Tiger™ Offset Disc

The **NEW** Offset Stump Jumper II Disc offers you the great features of the stump jumper while removing the need for a bolt protector. The New Disc has a larger diameter offering increase support to the new 5/8" straight knives and or 5/8" grass blades. The illustration below shows a parts breakdown as well as the part numbers needed to order the new assembly.

OFFSET DISC KIT PART #06700089

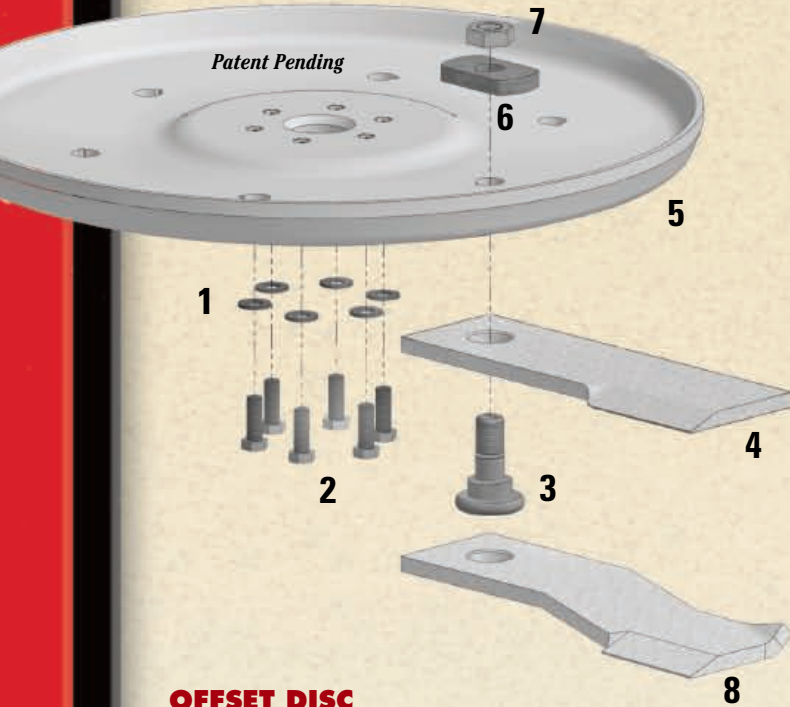
(Kit includes items 6, 5, 2, 1)

BENGAL TRB-50H
(Assembled with Brush Knives)

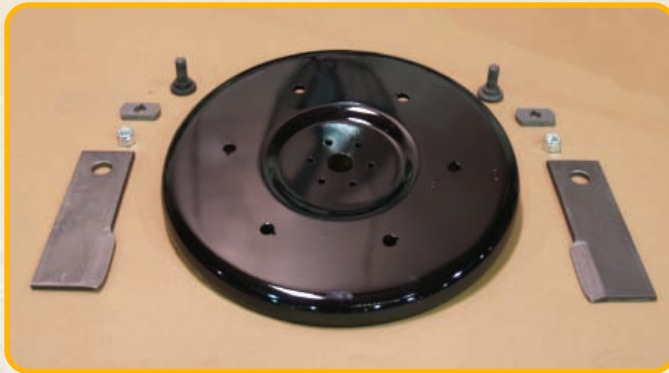
The new straight blade provides a longer life and greater strength at a lower list price.

The new grass blades offer high suction for cutting dense material.

Upgrade your old cutter assembly with a new larger diameter disc. The new disc provides more blade support resulting in a higher strength cutting assembly. The new offset center also eliminates the need for a bolt protector.

- **One-piece 5/8" Thick Disc**
- **50,000 PSI Yield Strength**
- **Spun Formed**
- **Laser Cut**
- **Balanced**
